**HORIZONTAL DIRECTIONAL DRILL ANALYSIS
SLITTING MILL ROAD CROSSING
PADEP SECTION 105 PERMIT NO.: E23-524
PA-DE-0008.0000-RD
(SPLP HDD No. S3-0560)**

This reevaluation of the horizontal directional drill (HDD) installation of a 20-inch diameter pipeline under Slitting Mill Road has been completed in accordance with Condition No. 3 of the Stipulated Order issued under Environmental Hearing Board Docket No. 2017-009-L (Order). Condition No. 3 stipulates for HDDs initiated after the temporary injunction issued by the Pennsylvania Department of Environmental Protection (PADEP) Environmental Hearing Board (July 25, 2017), a reevaluation must be performed on HDDs for which an inadvertent return (IR) occurs during the installation of one pipe (20-inch or 16-inch diameter) where a second pipe will thereafter be installed in the same right-of-way (ROW).

HORIZONTAL DIRECTIONAL DRILL REDESIGN

Figure 2. Revised 20-Inch HDD Plan and Profile

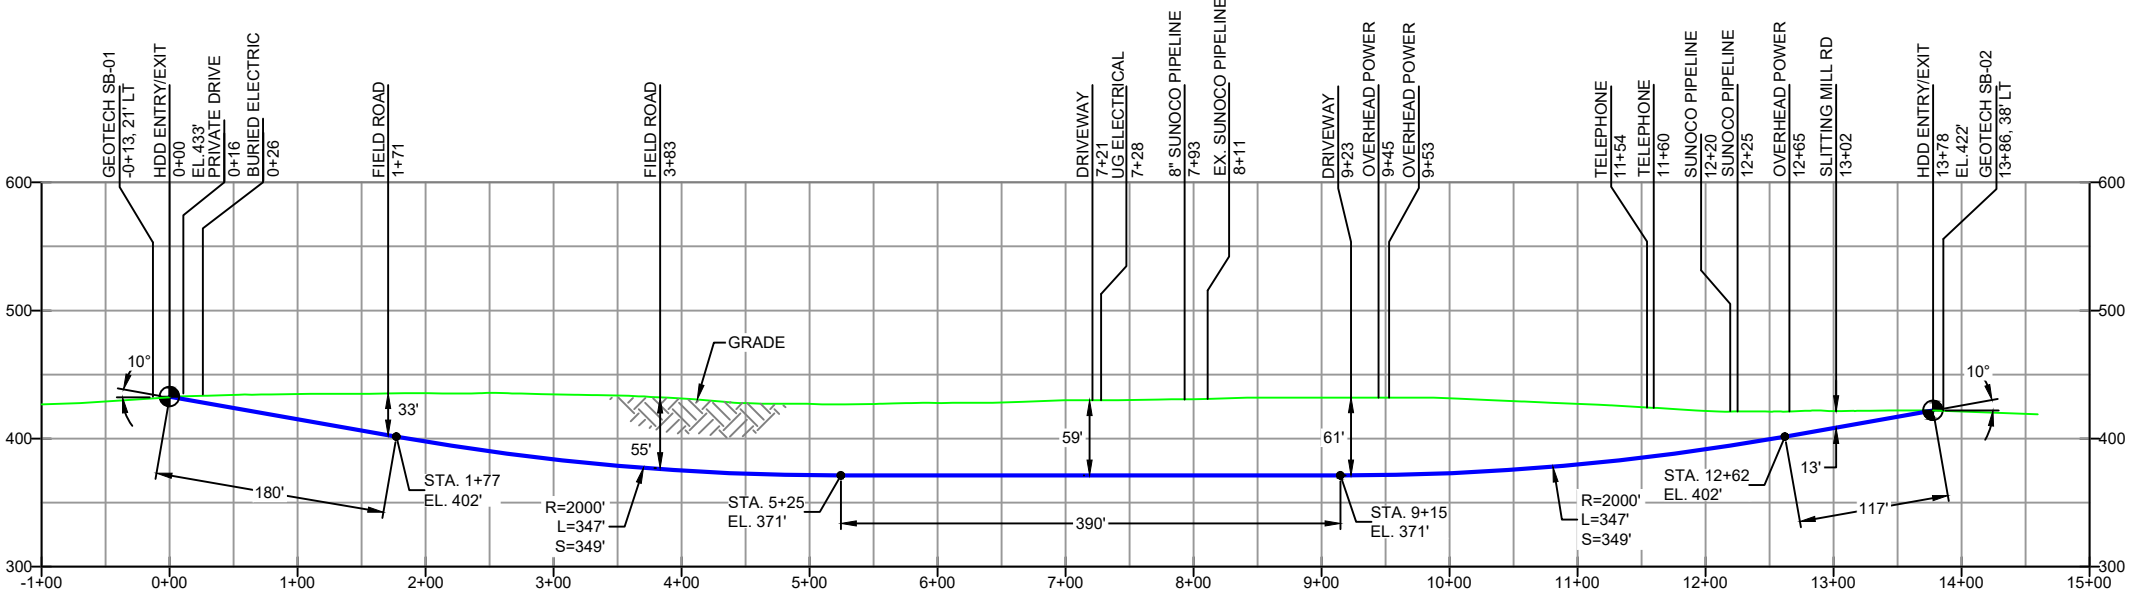
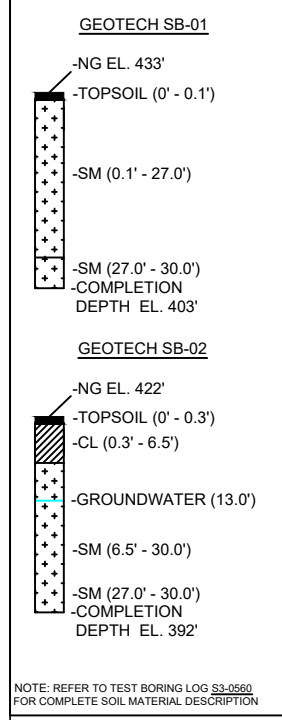
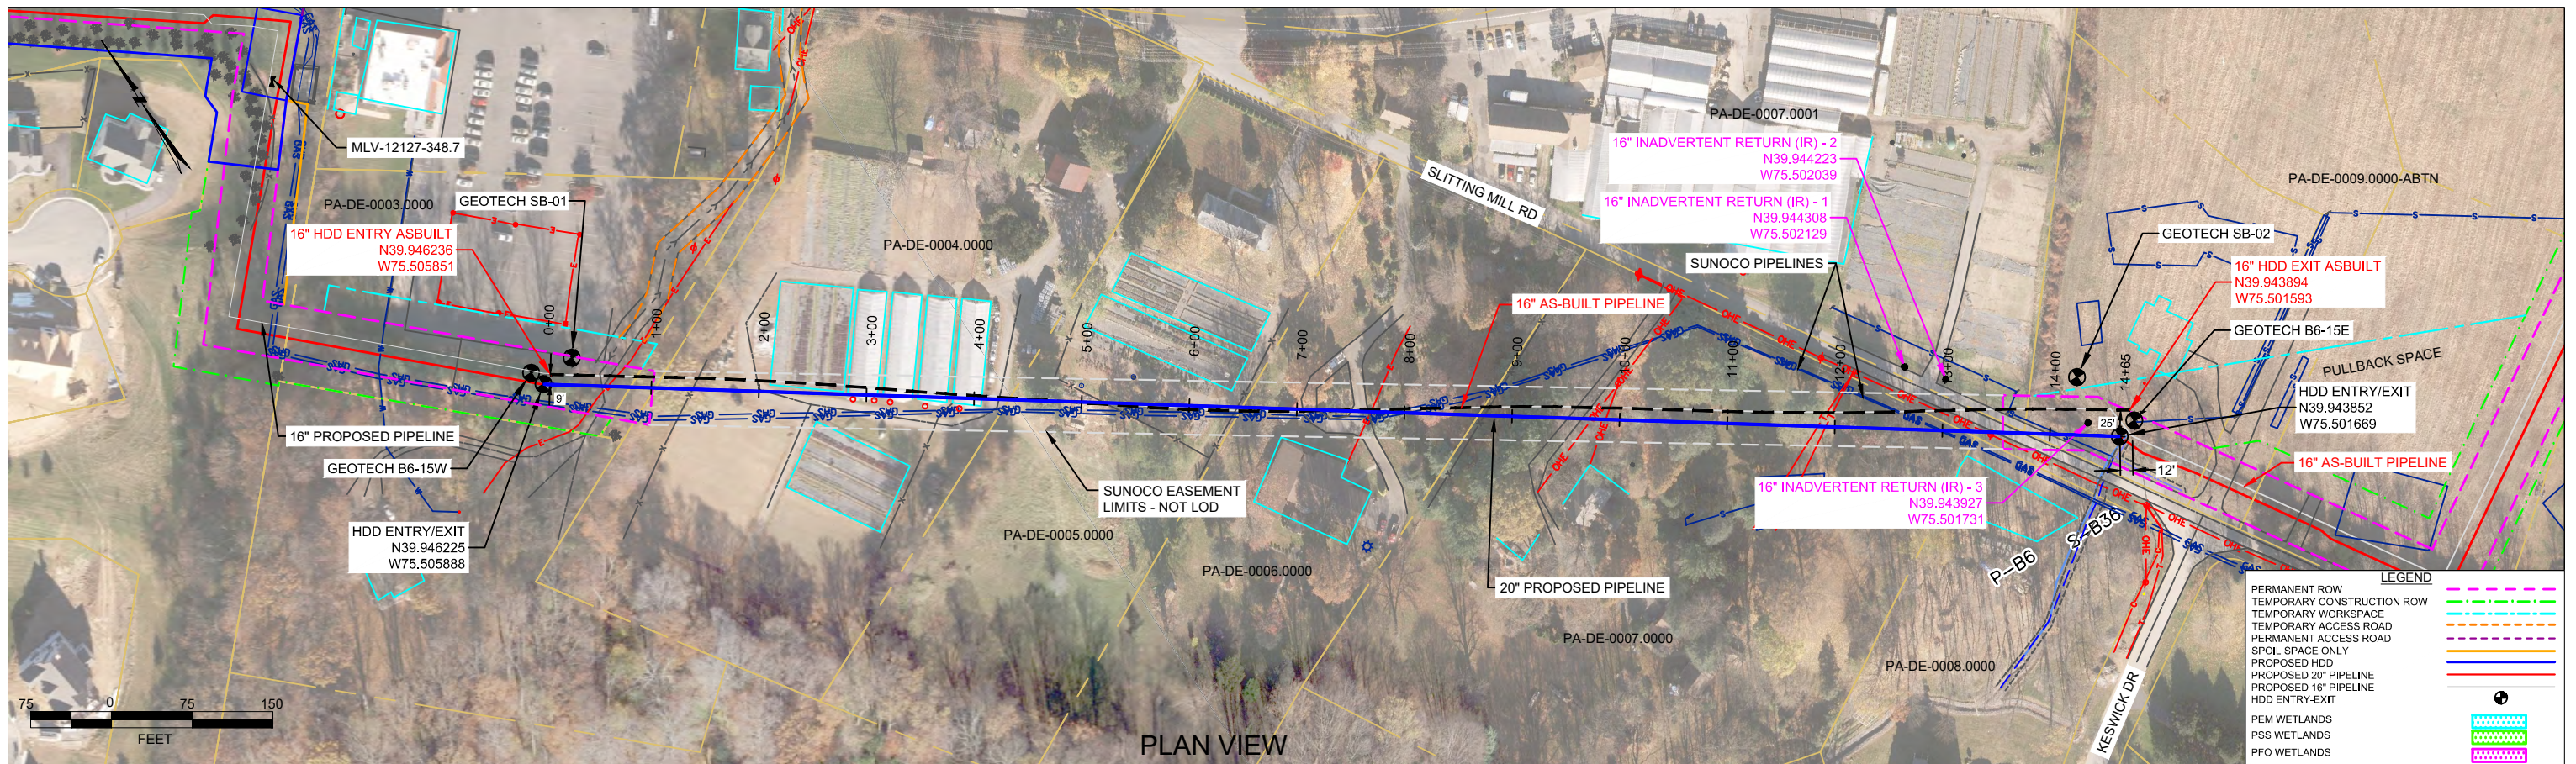
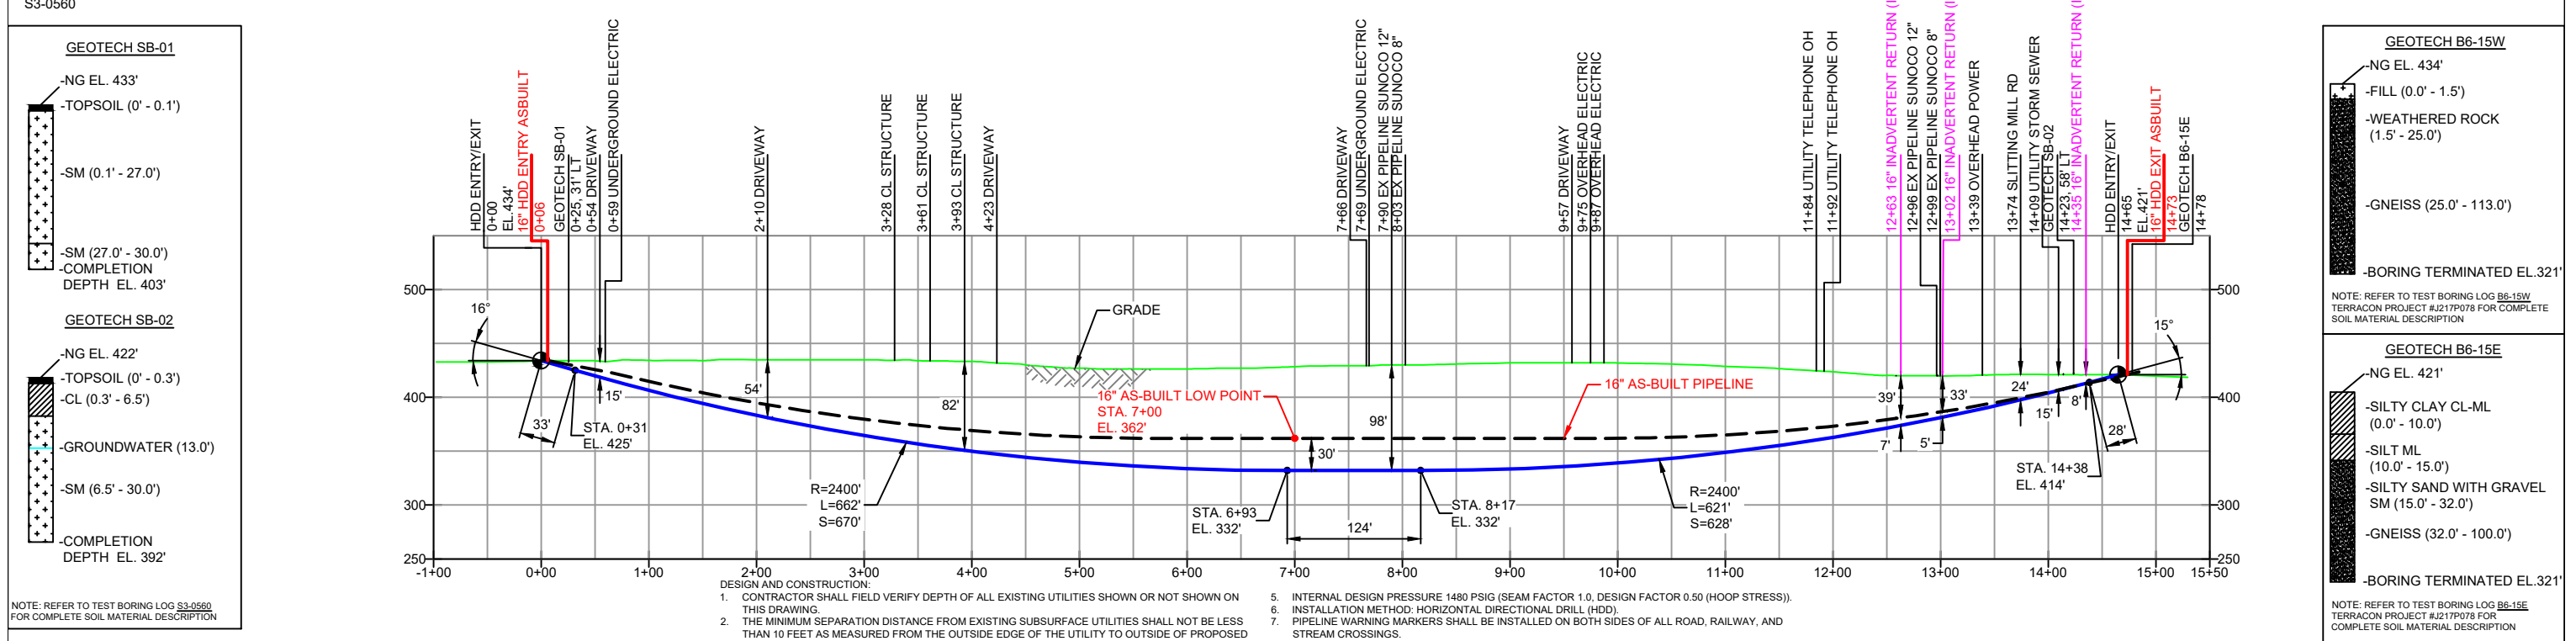
SPLP has considered all geologic data and the events during installation of the 16-inch pipeline and has redesigned the 20-inch HDD profile. A summary of the redesign factors is provided below. The original and redesigned HDD plan and profile for the 20-inch pipeline are provided in Attachment 2.

- Horizontal length: 1,465 feet (ft)
- Entry/Exit angles: 15 - 16 degrees
- Maximum depth of cover: 98 ft
- Pipe design radius: 2,400 ft

The redesigned HDD profile increases the angle of entry and exit to reduce the potential for IRs as occurred during installation of the 16-inch pipeline. This design nearly maximizes the profile potential and leaves 124 ft of horizontal run for any required corrections before proceeding into the exit radius. The remaining design factors are below the pipeline stress allowances for all points of analysis.

NOTES		REF. DRAWING		REVISIONS		SUNOCO PIPELINE, L.P.						
1. ALL COORDINATES SHOWN ARE IN LATITUDE AND LONGITUDE. ALL MSL ELEVATIONS ARE NAD83	ES-6.02	TO	ES-6.03	EROSION & SEDIMENT PLAN	EP3	SWITCHED 20" CENTERLINE LOCATION, INCREASED DEPTH OF DRILL AND ADDED GEOTECH INFORMATION	MRS	03/14/19	RMB	03/14/19	AMC	03/14/19

Based on the original and revised profile for the 20-inch HDD, the revised HDD profile increases the depth in bedrock for a majority of the HDD profile; therefore, adjustments to the plan of construction for the 20-inch pipeline represent a reduced risk of IRs that would impact uplands over the profile. The HDD does not pass beneath any Waters of the Commonwealth. Although no water supply impacts occurred during installation of the 16-inch pipe, four (4) private water supplies are within 100 feet of the alignment, representing a heightened risk for a water supply impact. This risk will be managed by SPLP, as it does for all private water supplies within 450-feet of HDD alignments, by offering pre-drilling water quality sampling, and temporary water supplies during the time of HDD installation. Upland and punch out IRs are common on entry and exit of the drilling tool and other measures are required to minimize IR potential. In particular, upon the start of this HDD, SPLP will employ the following HDD best management practices:
